STATE OF NORTH CAROLINA  
DEPARTMENT OF TRANSPORTATION

**Subject: Request for Modification to Section 404 Individual Permit and Section 401 Water Quality Certification** for the I-40/I-77 interchange improvements including I-40 from west of SR 2003 (Radio Road) to SR 2158 (Old Mocksville Road) and I-77 from south of SR 2321 (East Broad Street) to south of SR 2171 (Jane Sowers Road) in Iredell County. Division 12, TIP No. I-3819B. Debit \$570.00 from WBS 34192.3.2.

**References:** 1) Section 404 Individual Permit, Action ID No. SAW-2018-01504, issued January 21, 2020; 2) Section 401 Water Quality Certification No. WQC004203, NCDWR Project No. 20191006, issued November 19, 2019 and revised January 30, 2020.

The purpose of this letter is to request a modification to the United States Army Corps of Engineers (USACE) Section 404 Individual Permit and associated North Carolina Division of Water Resources (NCDWR) Section 401 Water Quality Certification for the above referenced project. This request letter includes a variance request for specific cross-pipes that will not be embedded, revisions to the drainage design, and modifications to permitted impacts.

UTILITY PERMIT  
DRAWING  
SHEET 3a OF 8  
Rev. 11/02/2020

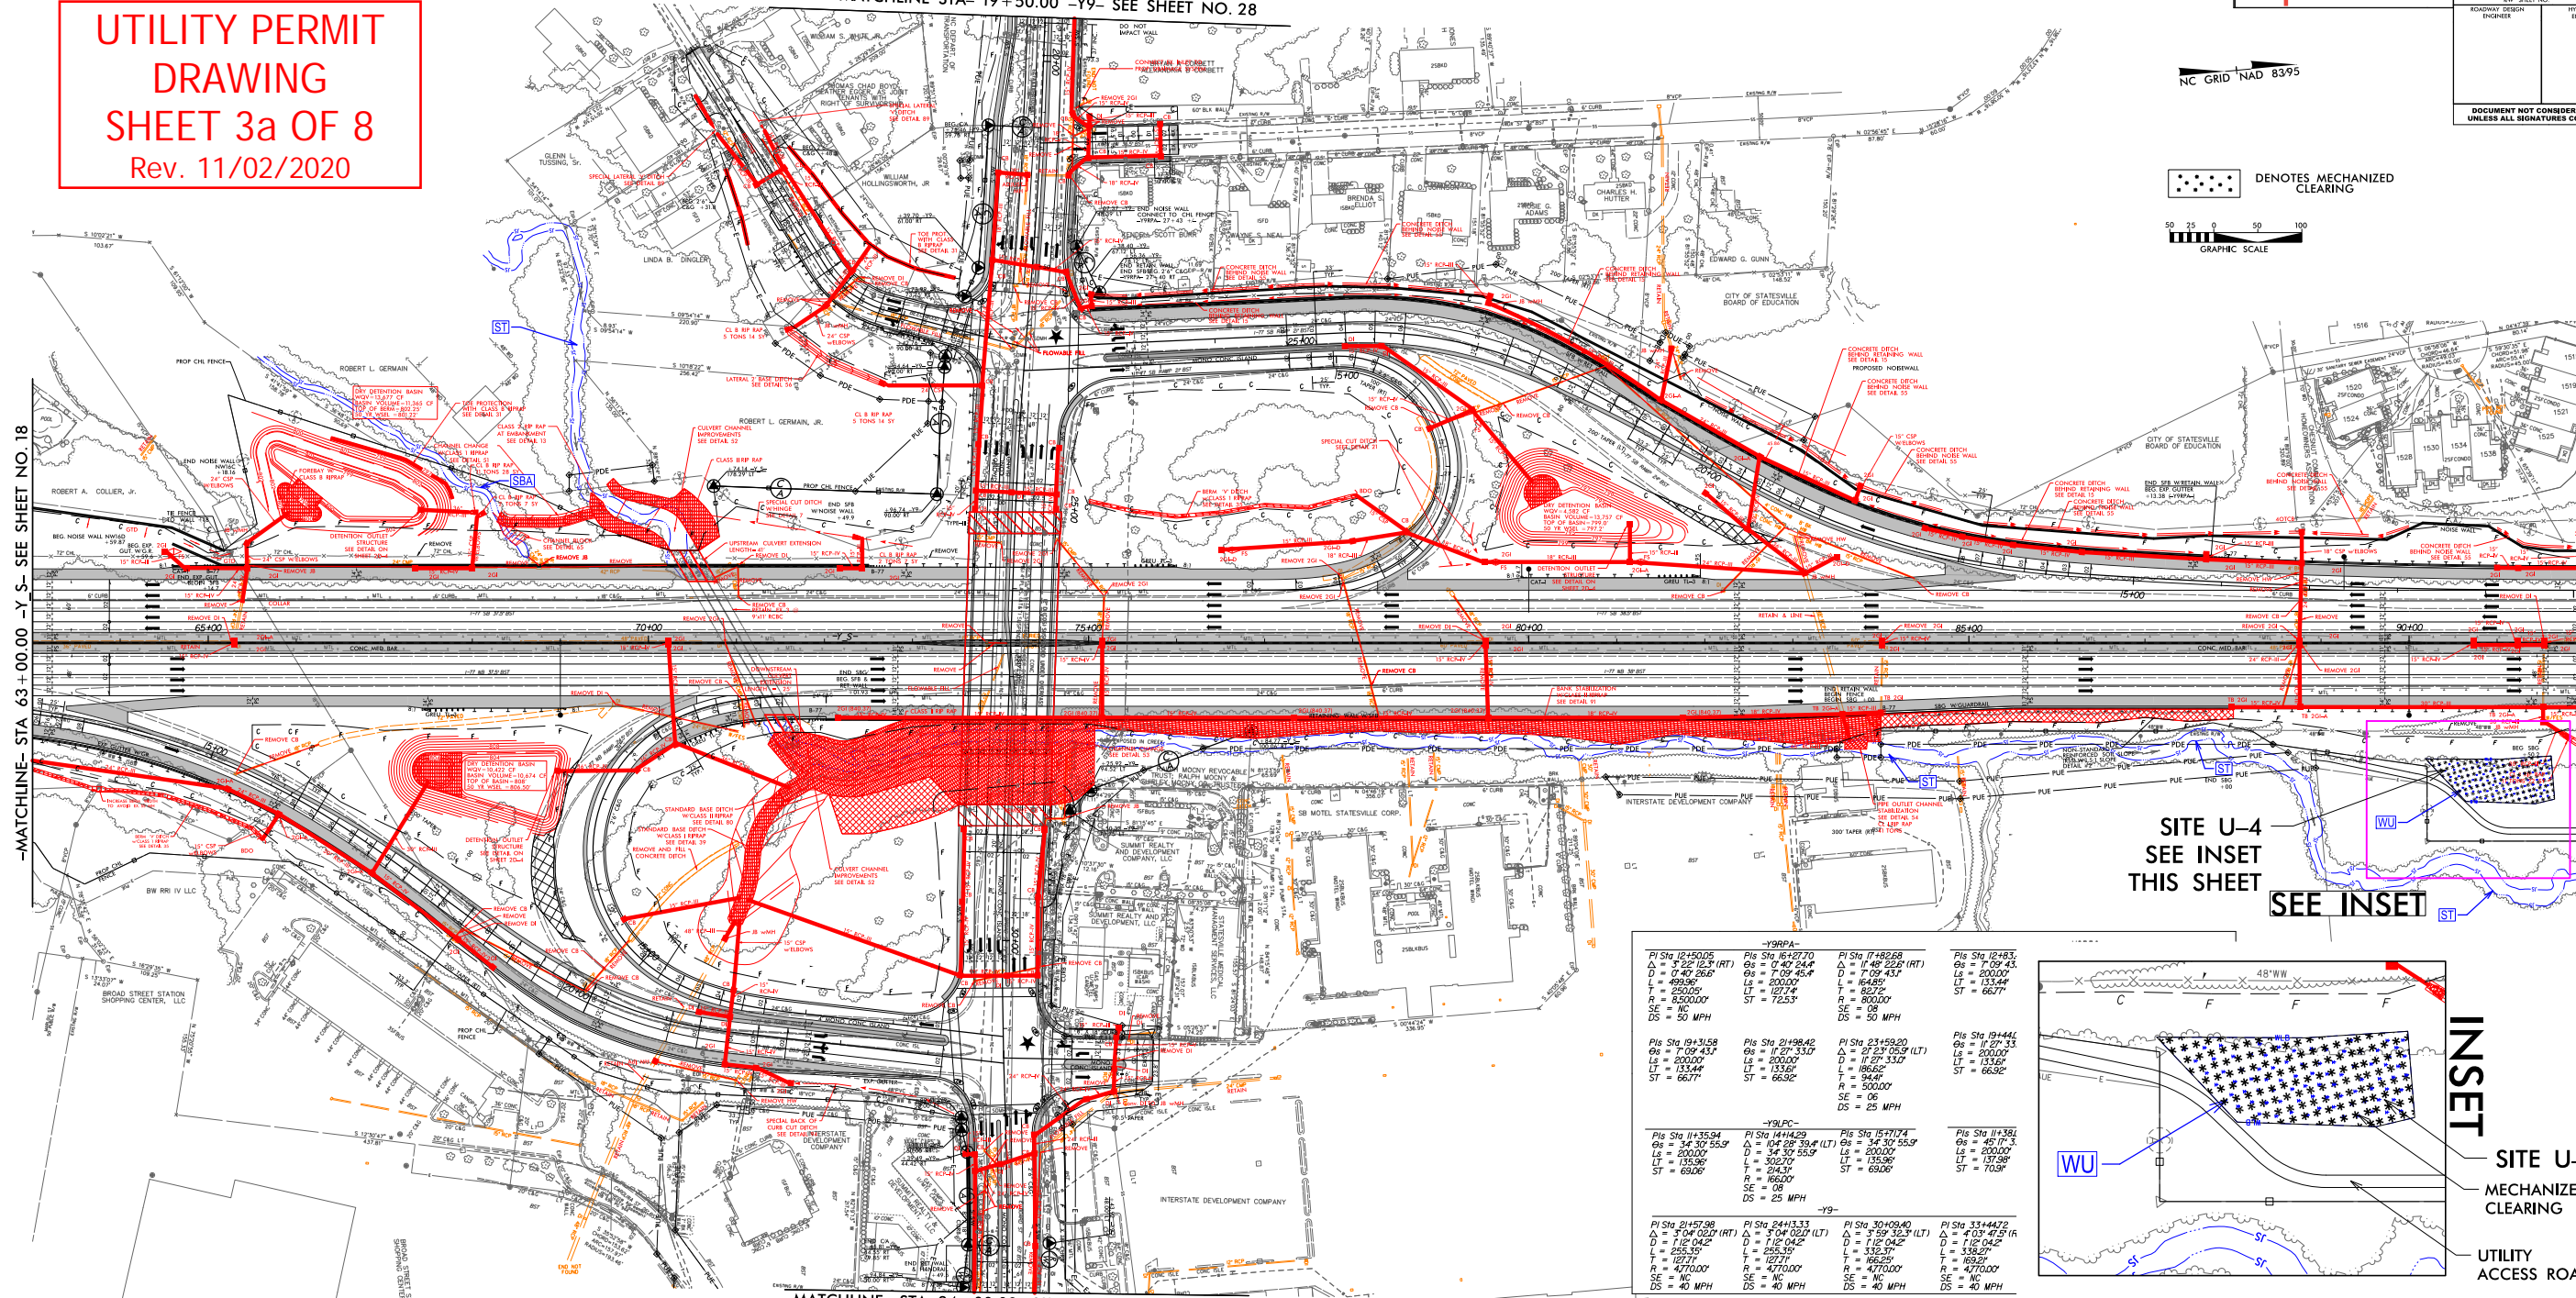
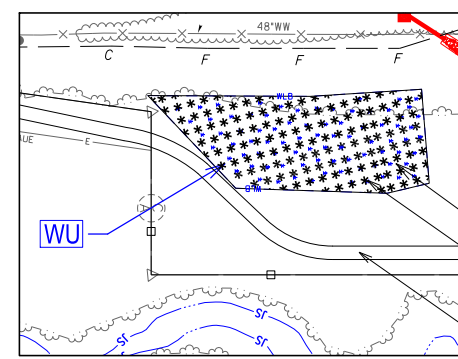
Utility Site U-4 (Utility Permit Drawing Sheet 3a) – During the construction of an access road for City of Statesville Power’s 334 circuit relocation work, the contractor inadvertently allowed clearing in wetland WU. This activity resulted in 0.14 acre of mechanized clearing impacts to wetland WU. The cleared wetland has been replanted with wetland seed mix following NCDOT’s Roadside Environmental Unit guidance and standard procedures. The revised utility permit drawings and summary table have been updated to include the 0.14 acre of mechanized clearing impacts that were not previously permitted.
